SERVICE LETTER 225

Piper PA-12 & PA-18 Hydraulic Pump Replacement on 2100A Floats

Aircraft Makes/Model(s):	Float Model(s):	Compliance: Optional	By: MAB
Piper PA-12 & PA-18	2100A	Part Number: 1011838	Approved: SDW
		Date: 5/7/2021	Revision: A

PA-12 ONLY

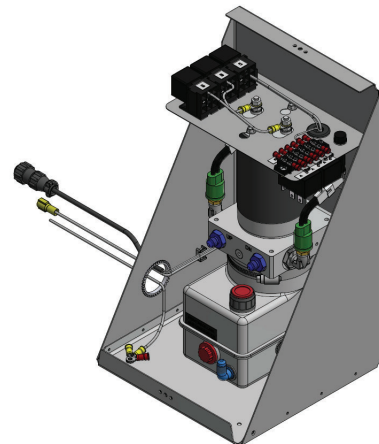
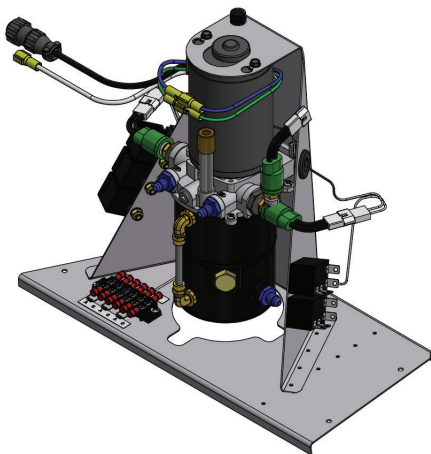
PA-12 Hydraulic Pump Assembly p/n 21A09000-233 and PA-18 Hydraulic Pump Assembly 21A09000-210 have both been discontinued. This service letter provides the option to replace them with pumps p/n 1011830 for the PA-12 or 1011805 for the PA-18 with Standard Baggage or 1011830 for the PA-18 with Extended Baggage.

PA-12 DISCONTINUED
HYDRAULIC PUMP 21A09000-233

PA-12 NEW
HYDRAULIC PUMP 1011830

1. Disconnect aircraft battery.
2. Disconnect single pin Molex connector for GA1 wire.
3. Disconnect 4 pin CPC connector from hydraulic power pack assembly 21A09000-233.

8. Unbolt and remove hydraulic power pack 21A09000-233 from baggage floor.
9. Install new hydraulic power pack 1011830 onto baggage floor using existing hardware.

10. Re-install hydraulic lines 21A09000-204 to pump manifold up and dn ports
11. Re-install hydraulic line 21A09000-208 to hydraulic power pack reservoir fitting.

PA-18 STANDARD BAGGAGE ONLY

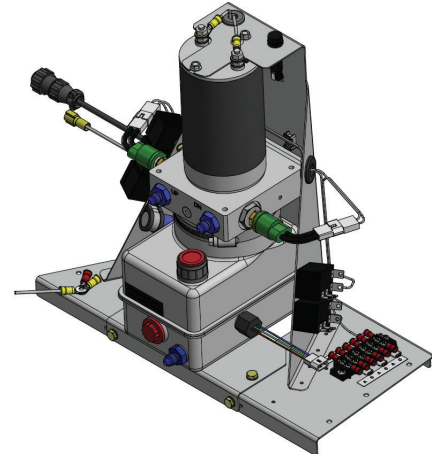
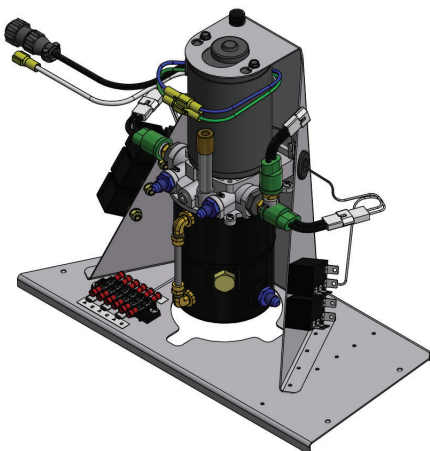
PA-18 DISCONTINUED
HYDRAULIC PUMP 21A09000-210

PA-18 NEW
HYDRAULIC PUMP 1011805

1. Disconnect aircraft battery.
2. Disconnect single pin Molex connector for GA1 wire.
3. Disconnect 4 pin CPC connector from hydraulic power pack assembly 21A09000-210.
4. If aircraft has a hydraulic low level warning system, disconnect wire harness from sensor in reservoir.
5. Drain hydraulic fluid from hydraulic power pack reservoir.
6. Disconnect and cap 21A09000-208 hydraulic line from reservoir to emergency hand pump.
7. Disconnect and cap 21A09000-204 hydraulic lines from pump up and dn ports to cross fitting.
8. Unbolt and remove hydraulic power pack 21A09000-210 and clamps on aircraft tubing.
9. Install new hydraulic power pack in same location as 21A09000-210 power pack. See image for mounting detail.

PA-18 EXTENDED BAGGAGE ONLY

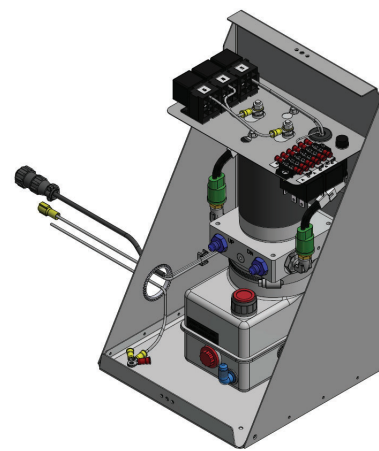
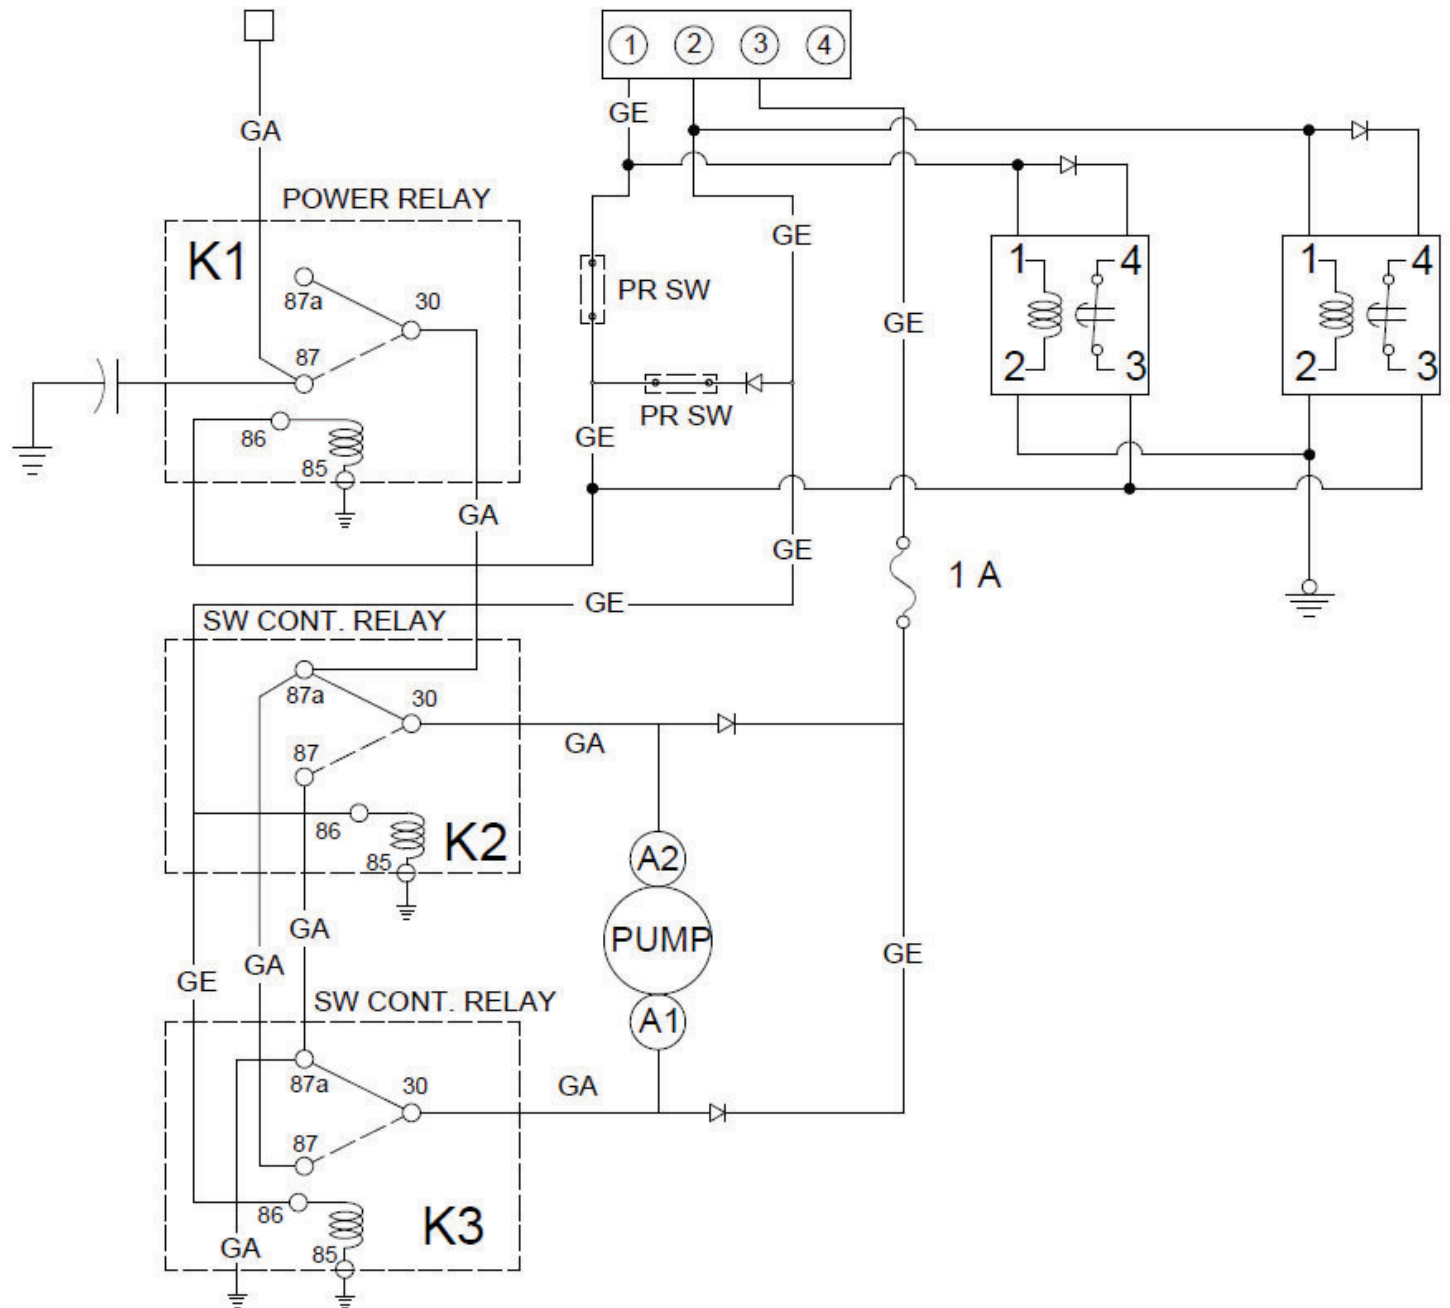
PA-18 DISCONTINUED
HYDRAULIC PUMP 21A09000-210

PA-18 NEW
HYDRAULIC PUMP 1011830

8. Unbolt and remove hydraulic power pack 21A09000-210 and clamps on aircraft tubing.
9. Do to the overall dimensions of the new pump, it will not fit in same location as 21A09000-210 hydraulic pump with the extended baggage. Locate 1011830 in baggage compartment at station 34.0. Do to the wide verity of floor thickness, use appropriate sized AN3 bolts to secure hydraulic power pack to baggage floor.

10. Re-route hydraulic lines 21A09000-204 and 21A09000-208 to new hydraulic power pack location. Cut hydraulic lines to fit and install 190772-4 fitting to all three hydraulic lines.

Electrical Schematic All Models

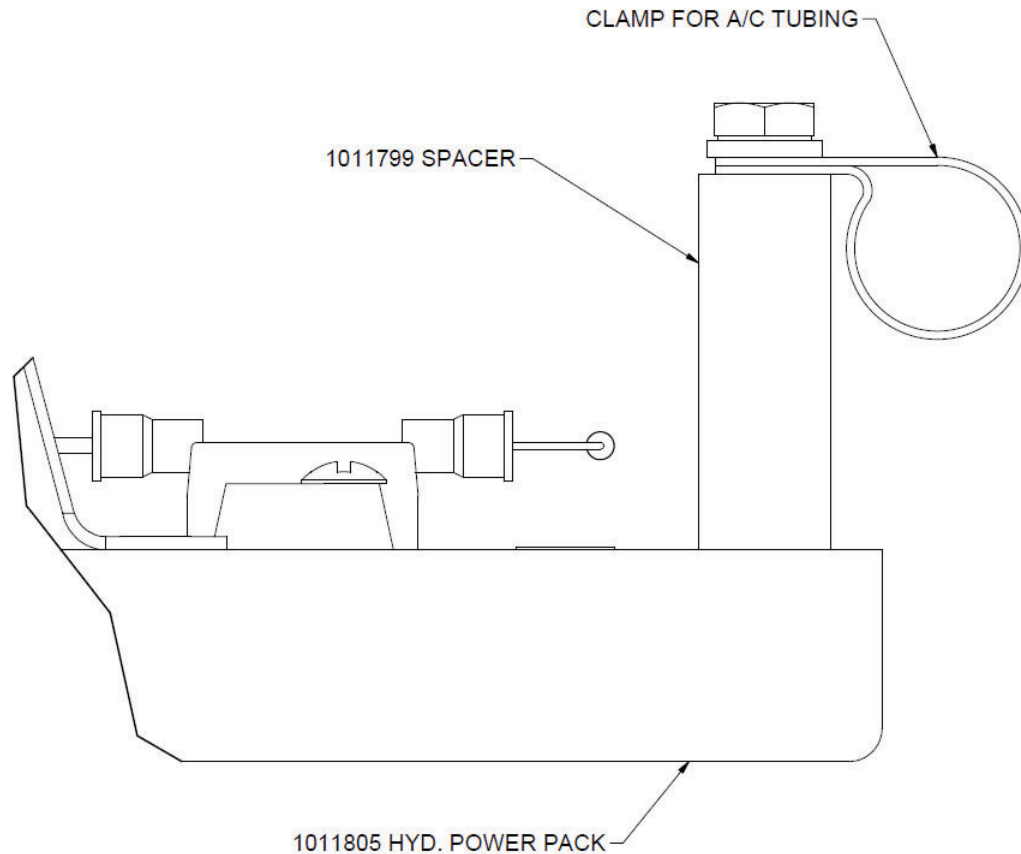
14. Cut single pin Molex connector from GA1 wire. Install 73F-250-32NL connector onto GA1 wire. Connect GA1 wire to power wire on hydraulic power pack. See electrical schematic.

14. Re-route and install 4 pin CPC connector. See electrical schematic.
15. Cut single pin Molex connector from GA1 wire. Re-route wire to new hydraulic power pack and install 73F-250-32NL connector onto GA1 wire. Connect GA1 wire to power wire on hydraulic power pack. See electrical schematic.
